# Access Compliance Report

## Public Rights-of-Way

### (Curb Ramps)

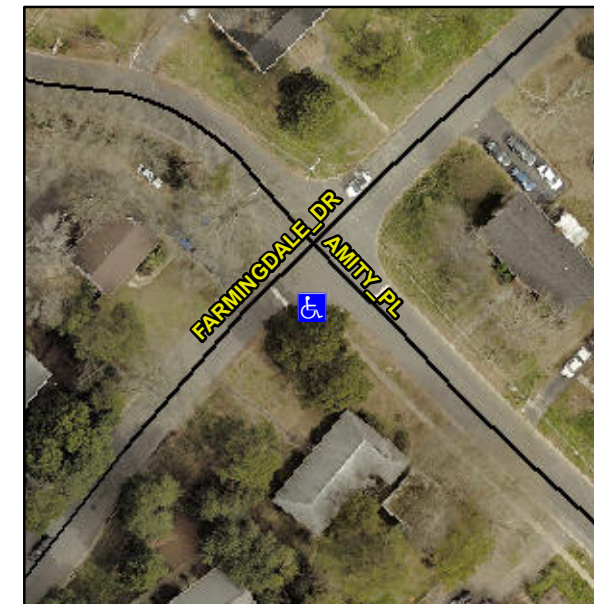
Intersection ID: N/A	Main Street: AMITY_PL	Cross Street: FARMINGDALE_DR	Location: SW
ADA ID: 4A960AE4CFDE	Ramp Type: PerpDiag	Initial Pass/Fail: Fail	Overall Compliance: No
Severity Score: 10			
Codes/Mitigation Info/Possible Solution		Field Measurements/Component Compliance

**Not Found, R304.5.1, R304.5.3**

Compliance	Description	Data	Compliance	Description	Data
N/A	Ramp Length (in)	35.0	Yes	Ramp Slope (%)	6.5
No	Ramp Width (in)	47.0	No	Ramp XSlope (%)	4.2
N/A	Flare Type LT	N/A	N/A	Flare Type RT	N/A
N/A	Flare Slope LT (%)	N/A	N/A	Flare Slope RT (%)	N/A
N/A	Flare Traversable LT?	N/A	N/A	Flare Traversable RT?	N/A
N/A	Landing Length (in)	N/A	N/A	DWS Provided?	N/A
N/A	Landing Width (in)	N/A	N/A	DWS Contrast?	N/A
N/A	Landing Slope (%)	N/A	N/A	DWS Length (in)	N/A
N/A	Landing X Slope (%)	N/A	N/A	DWS Full Width?	N/A
N/A	Landing Curb? (Y/N)	N/A	N/A	DWS Offset (in)	N/A
N/A	Shared Landing?	N/A			
N/A	Gutter Ponding?	N/A	N/A	Gutter Slope (%)	N/A
N/A	Gutter Lip Ht (in)	N/A	N/A	Gutter X Slope (%)	N/A
N/A	Painted X Walk1?	No	N/A	Painted X Walk2?	No
	X Walk 1 Direction	To NE		X Walk 2 Direction	To NW
N/A	X Walk 1 Width (in)	N/A	N/A	X Walk 2 Width (in)	N/A
	X Walk 1 Slope (%)	0.1		X Walk 2 Slope (%)	1.3
	X Walk 1 X Slope (%)	2.3		X Walk 2 X Slope (%)	0.0

**Remove & Replace Curb Ramp With Two New Directional Ramps or Equivalent.**
